DLL Classification PSE Power Increase

David Tremblay
Hewlett Packard Enterprise
Rev 2.3

Proposed Baseline Text

Figure 33–49—PSE power control state diagram

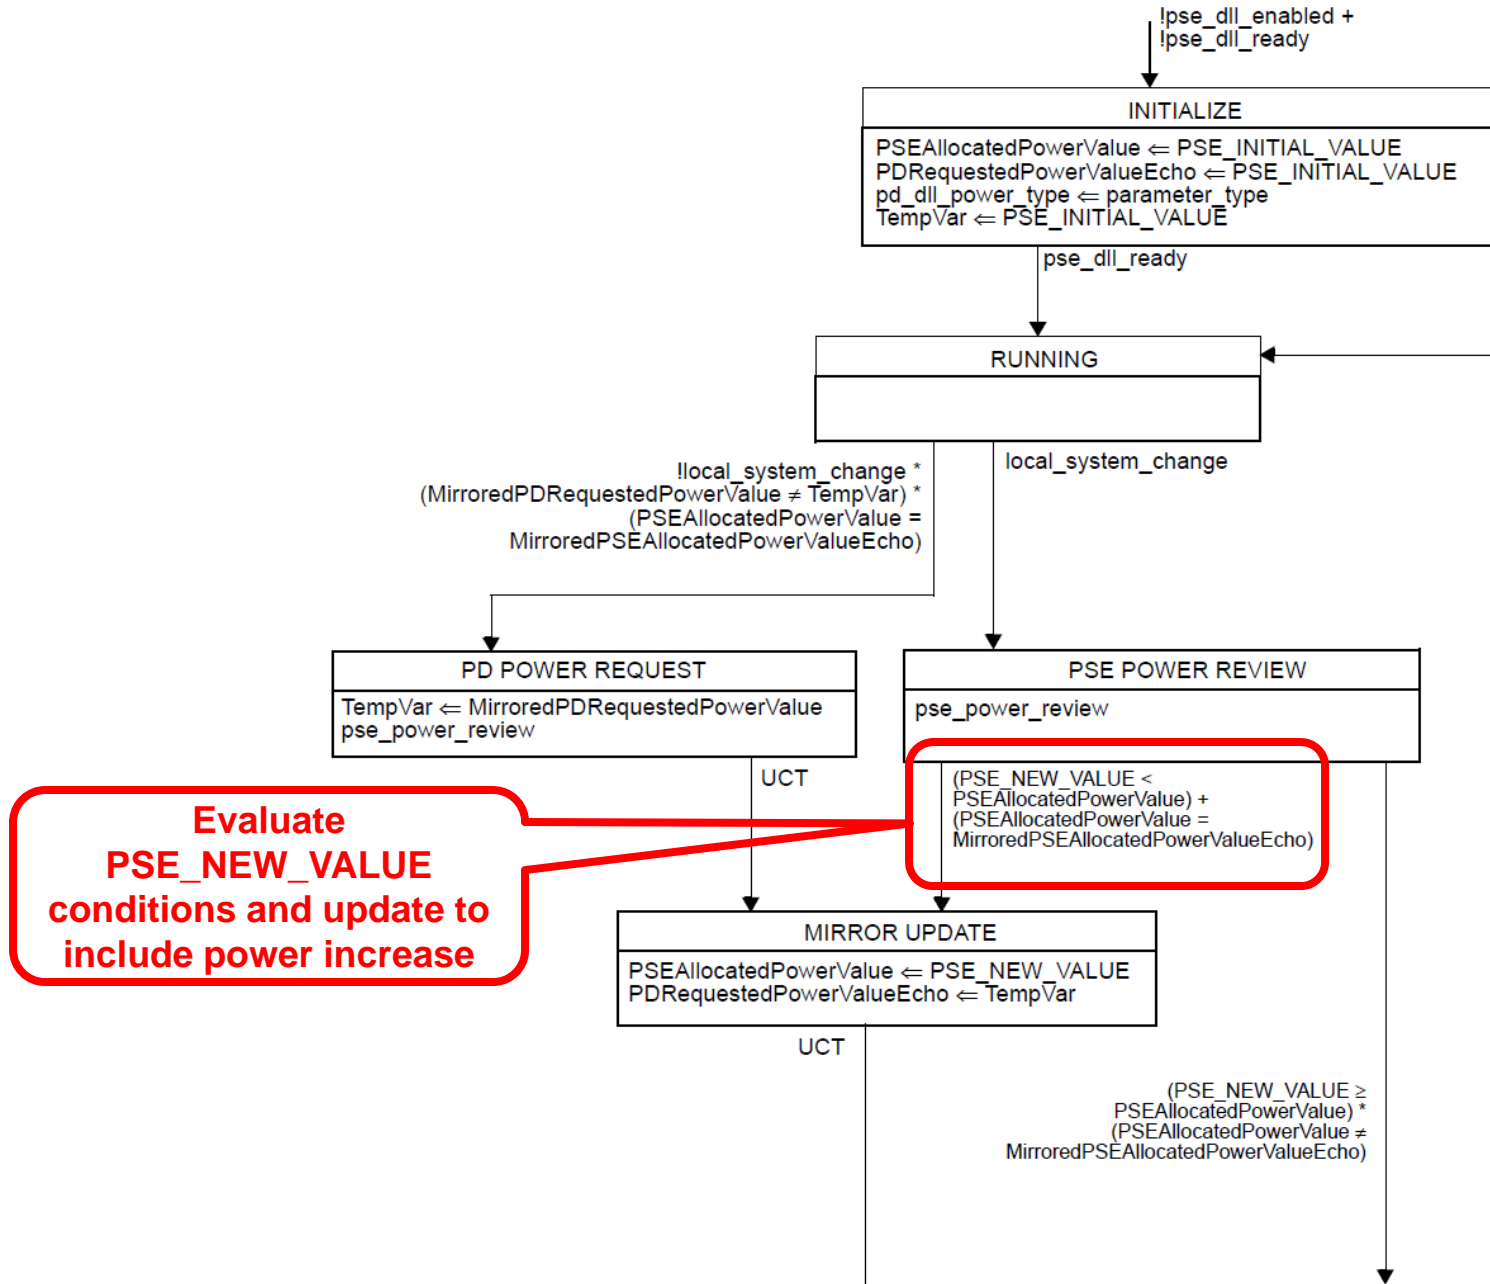
Text does not explicitly include a state change for PSE power increase

A PSE is considered to be in sync with the PD when the value of PSEAllocatedPowerValue matches the value of MirroredPSEAllocatedPowerValueEcho. When the PSE is not in sync with the PD, the PSE is ~~only~~ allowed to ~~decrease~~ its power allocation.
~~change~~

Adopt proposed baseline text in tremblay_01_0516_rev02_03, evaluate PSE_NEW_VALUE conditions and update to include power increase in Fig 33-49
